**STAFF REPORT
CITY OF DONALD PLANNING COMMISSION**

FILE: Site Development Review #SDR 2023-01

REQUEST: **Site Development Review approval for demolition of the existing Donald Café structure and replacement with a new mixed-use building containing a restaurant on the ground floor and one residential apartment on the second floor. Other proposed site improvements include a covered eating patio, small plaza, landscaping, parking spaces in the rear to serve the apartment, and stormwater planters. A Lot Line Adjustment application was submitted concurrently to consolidate the three small underlying historic lots into one.**

LOCATION: The Donald Café. 10780 Main Street NE in Donald. Block 7 Lots 3, 4, and 5.

FRONT ELEVATION (NORTH)

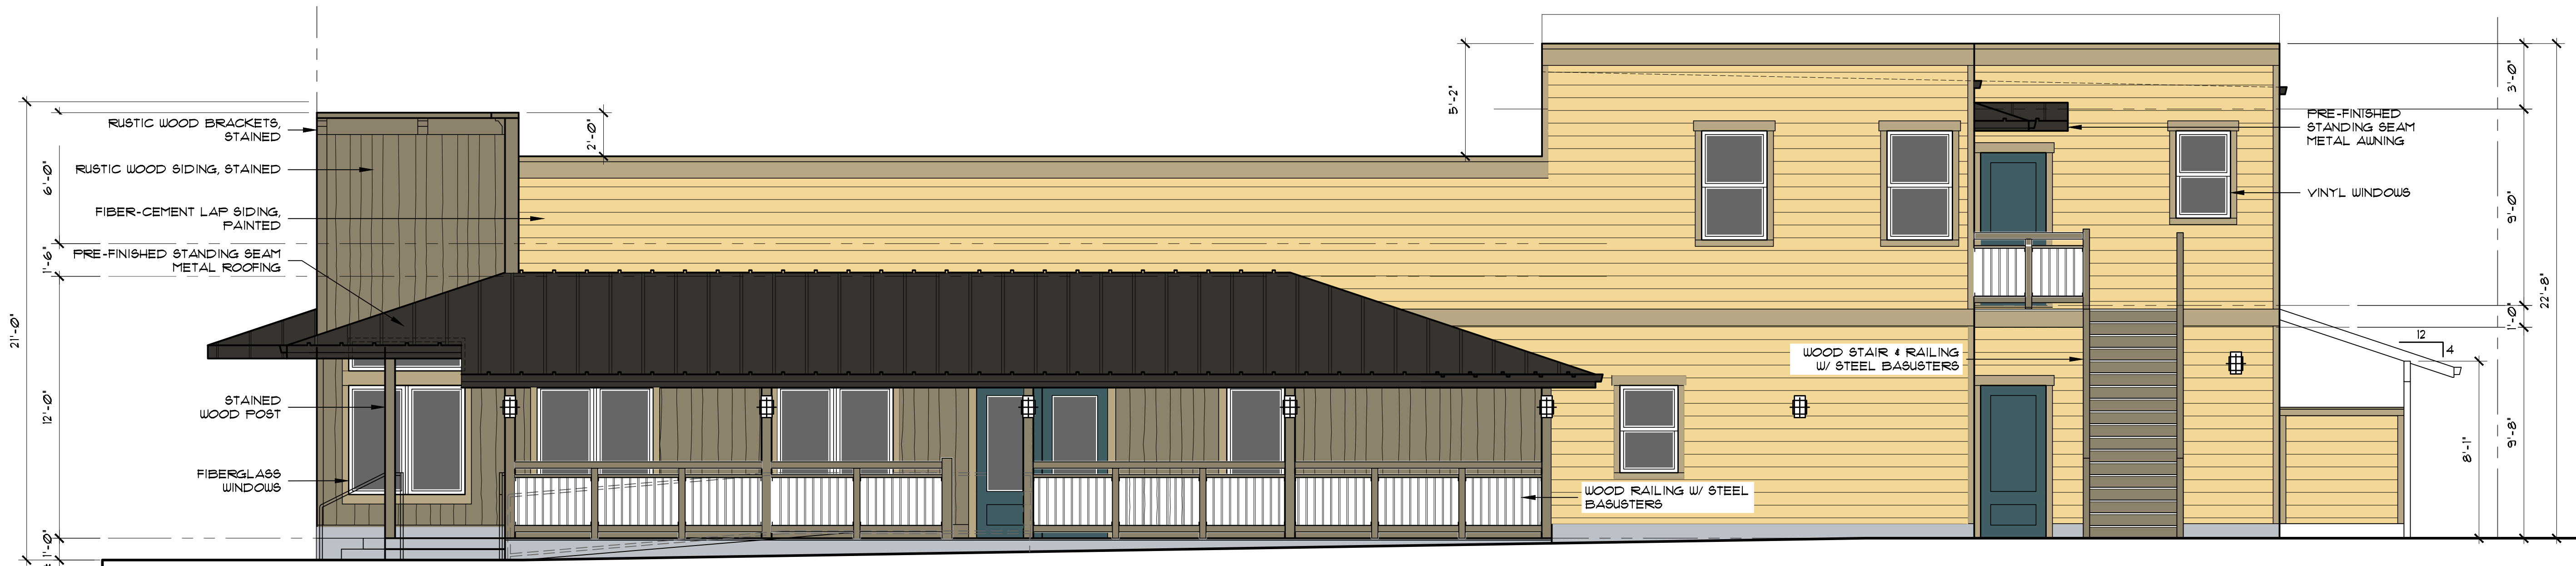
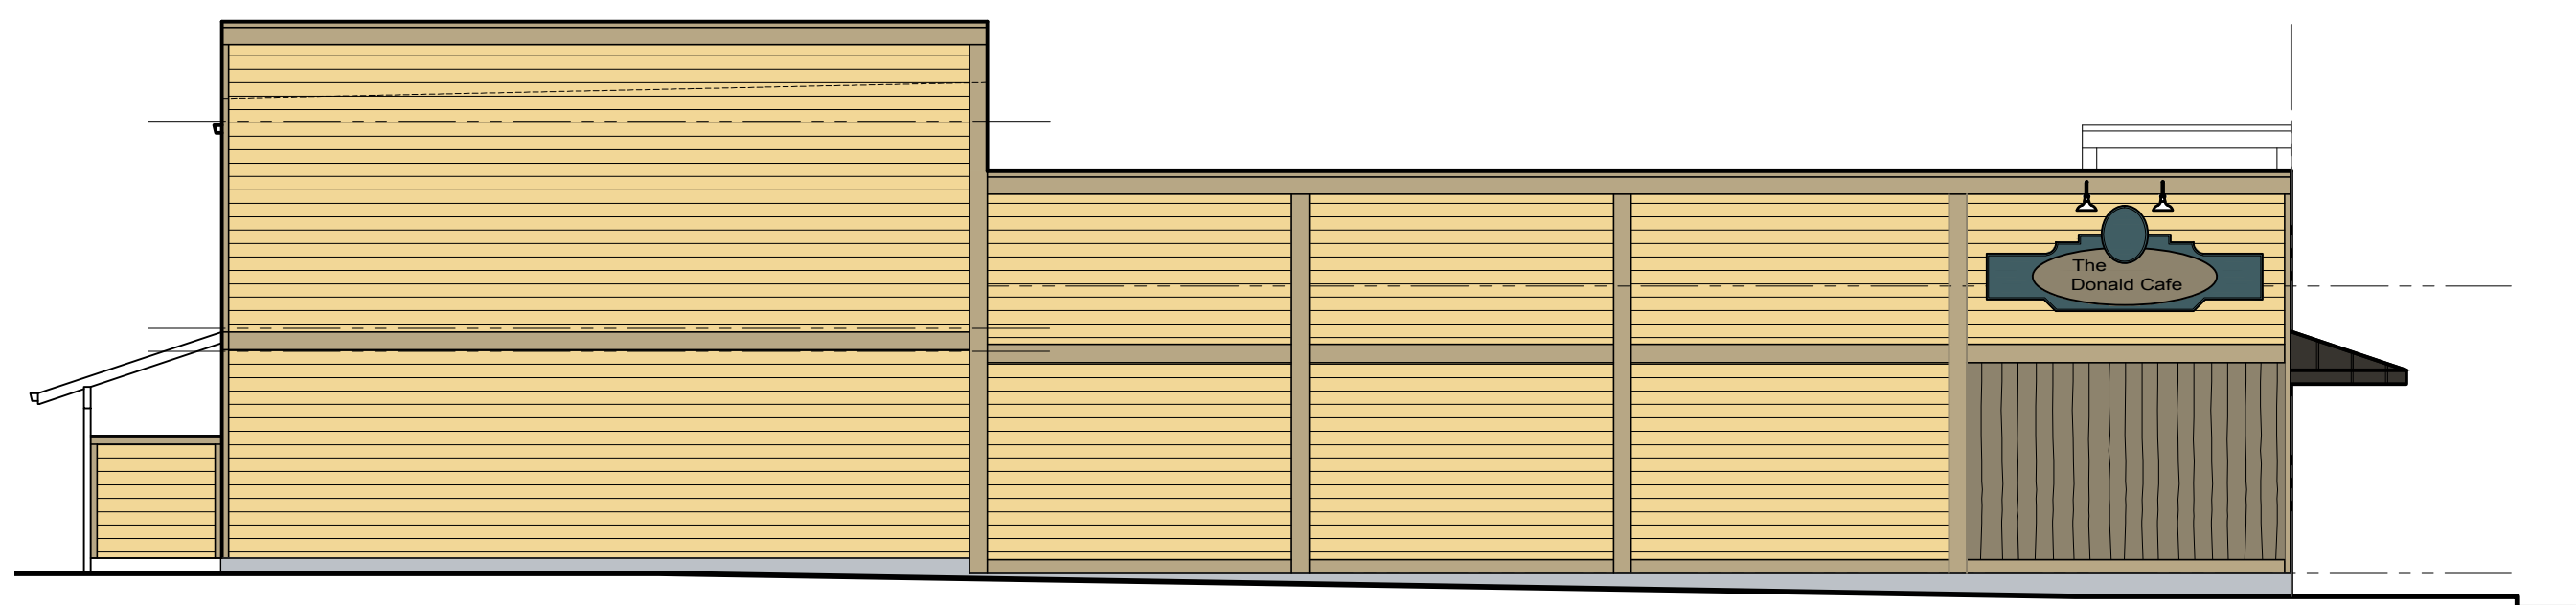
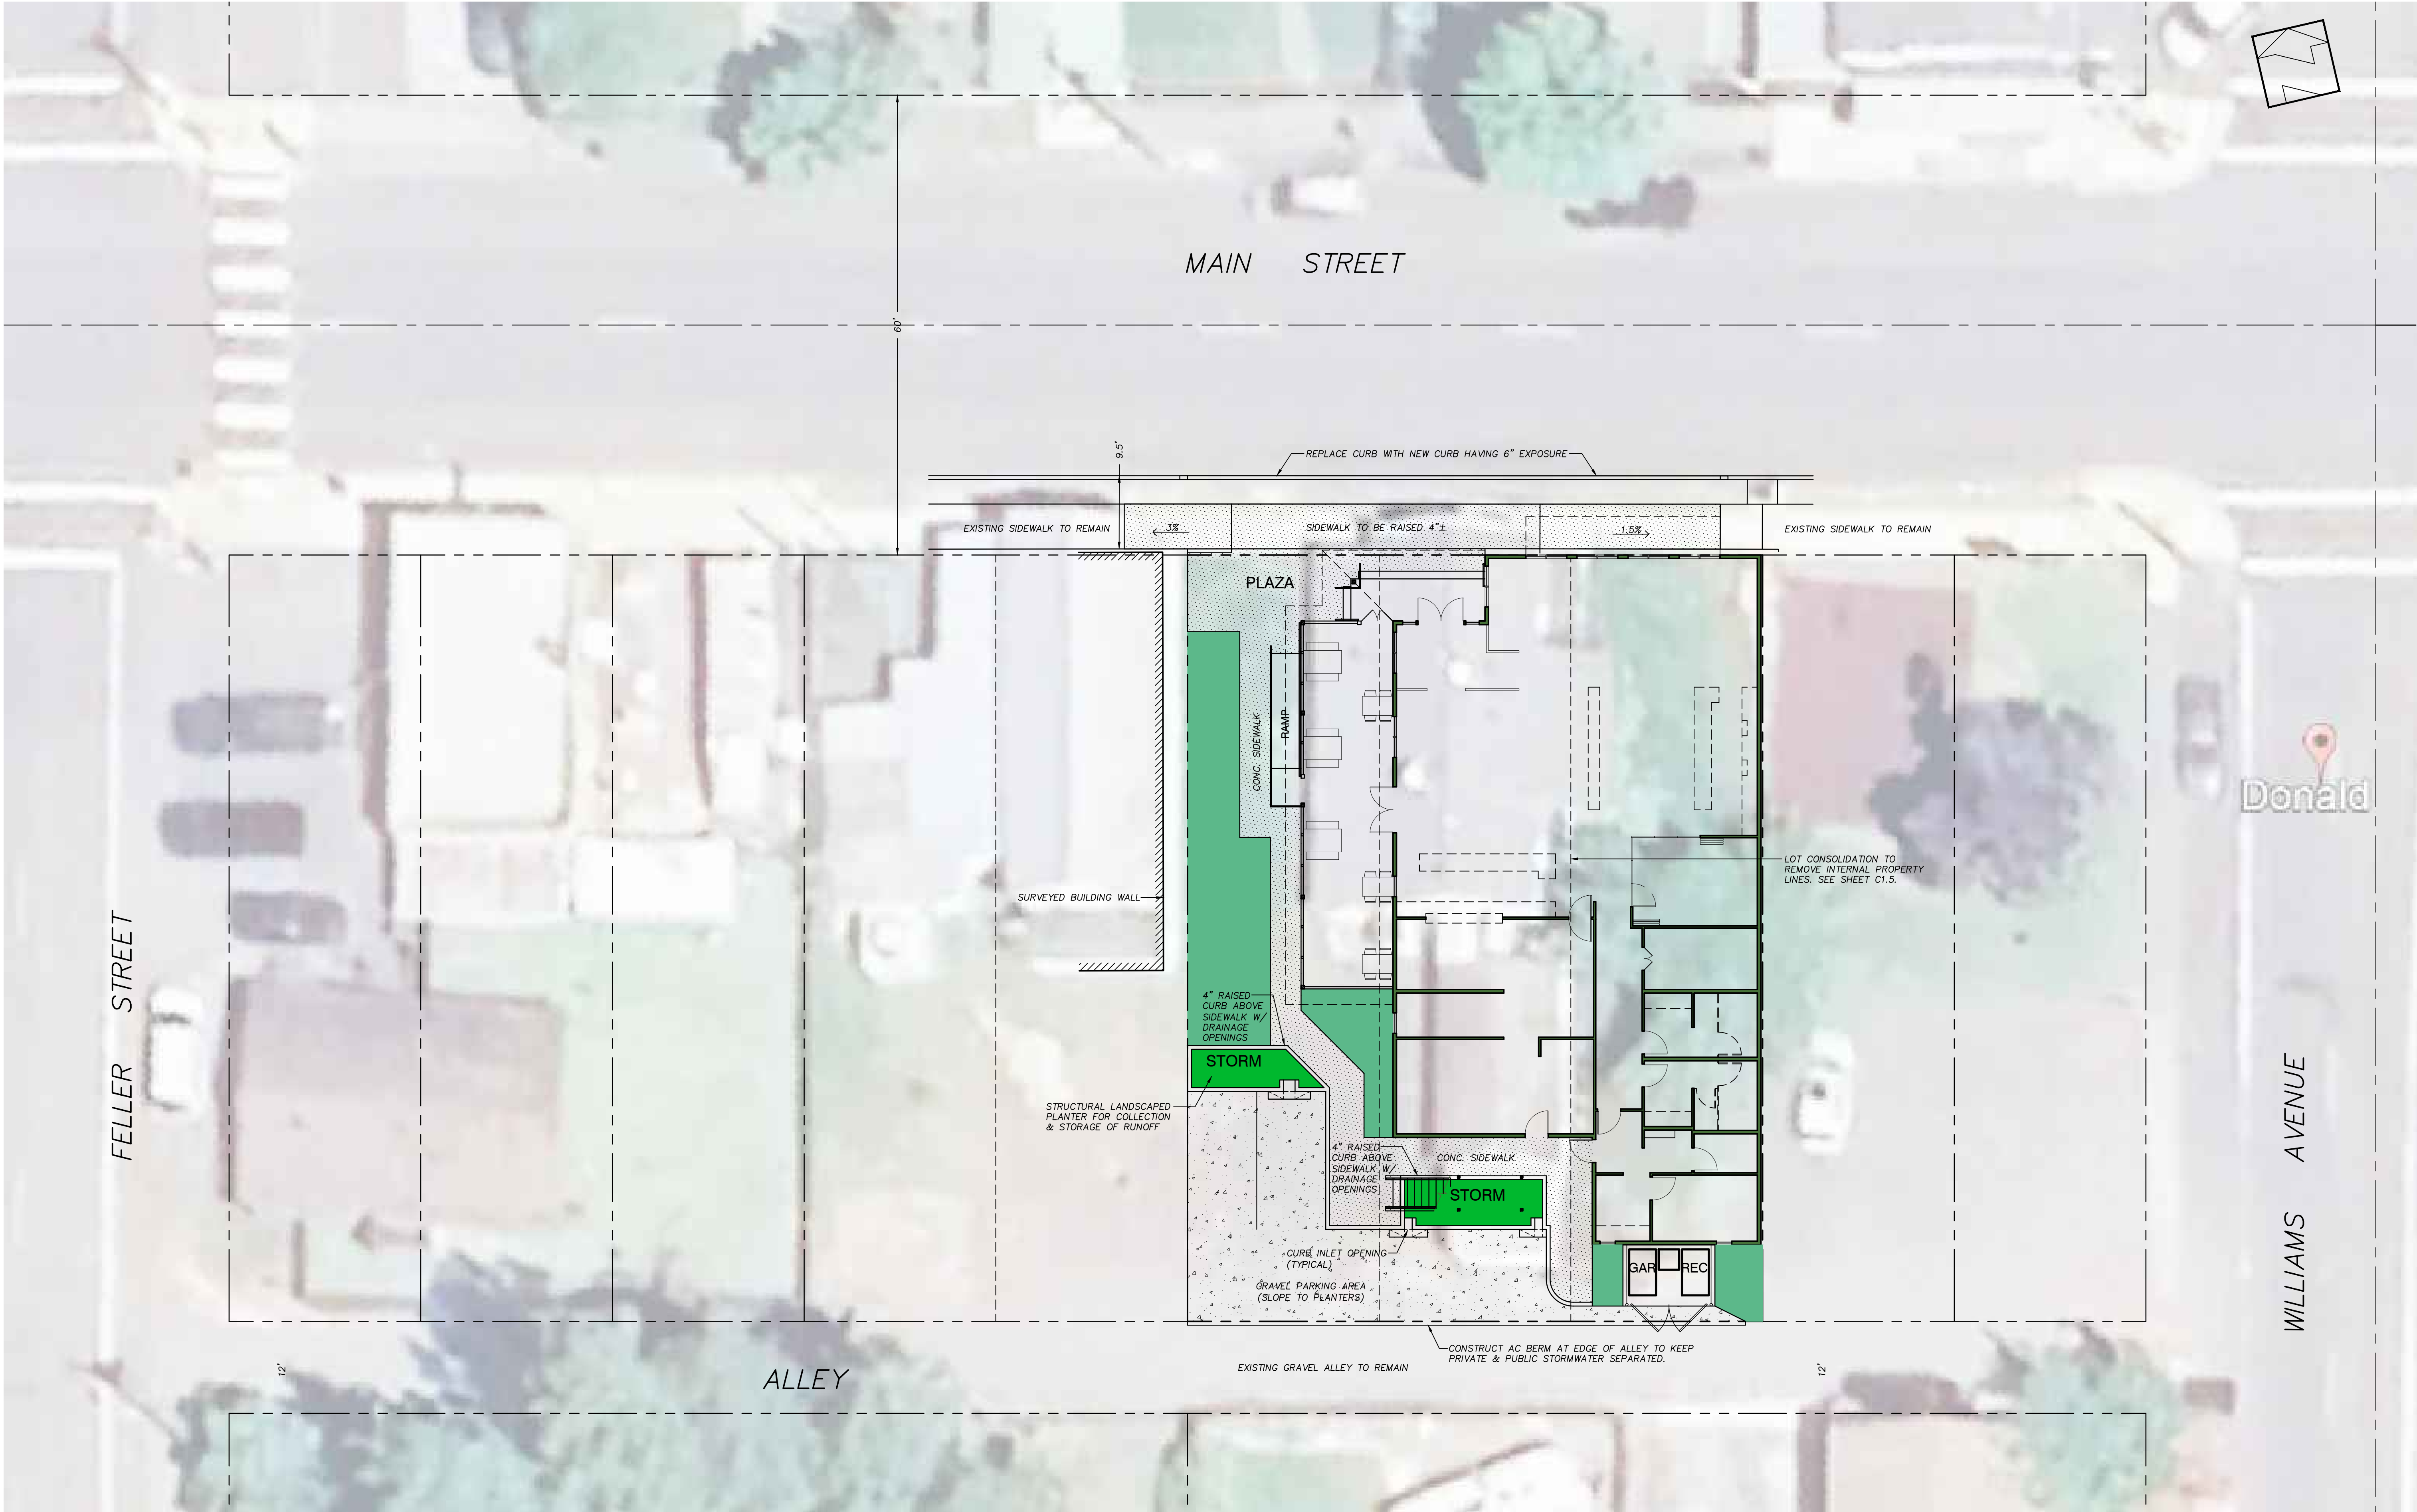
- B. Pursuant to DDO 2.108.04(C)(3), applicant shall demonstrate compliance with the intent to provide a minimum of 30% window transparency (rather than simply window and door openings) on the west side elevation facing the courtyard. False windows may be acceptable to balance design intent with security concerns.

- C. Pursuant to DDO 2.108.04(C)(4), applicant shall demonstrate compliance with the intent to provide a minimum of 30% window transparency on the rear (south) side of the building. False windows may be acceptable to balance design intent with security concerns.

Storm Drain Plan

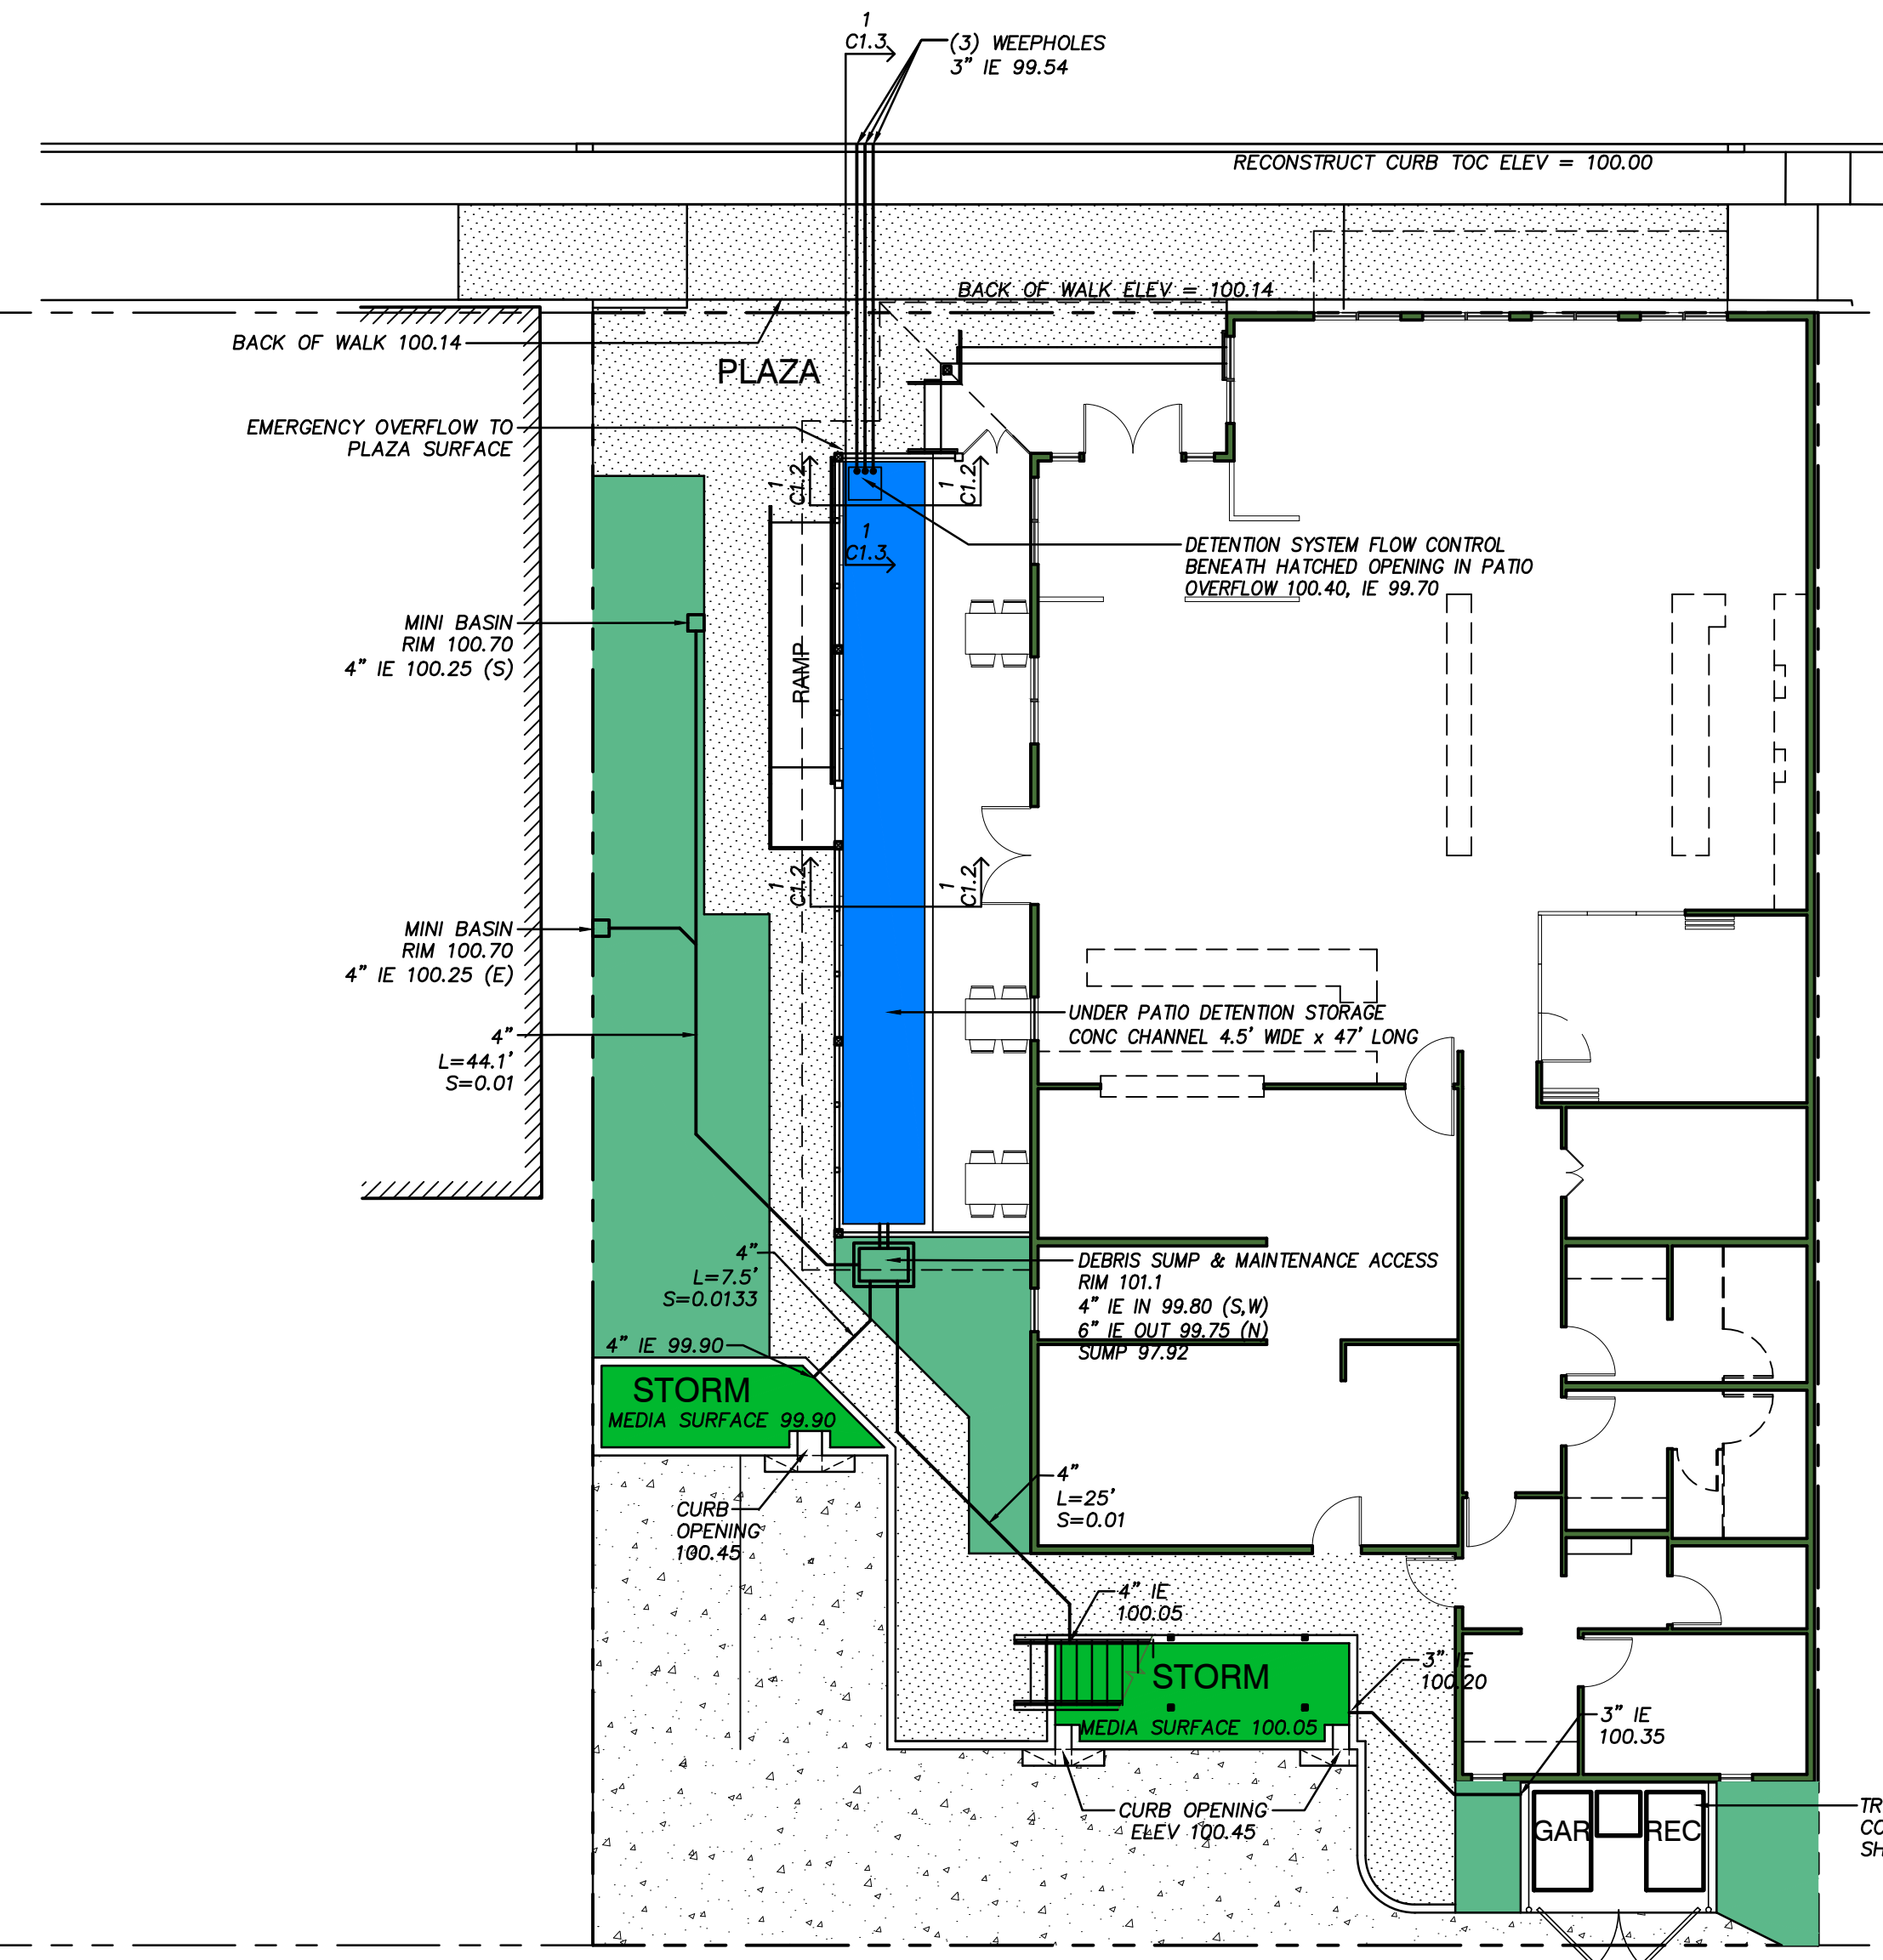
- Sheet C1.2, Storm Drain: Concerns of floor drain connected to sewer system at GAR and REC area. Potential for I&I source, run off water entering the sewer system. These types of connections are prohibited.

- Sheet C1.2, Storm Drain: Minimum storm drain pipe slope for mains and laterals are 1%. In all cases where less than 1% is not achieved, a Design Exception is required.
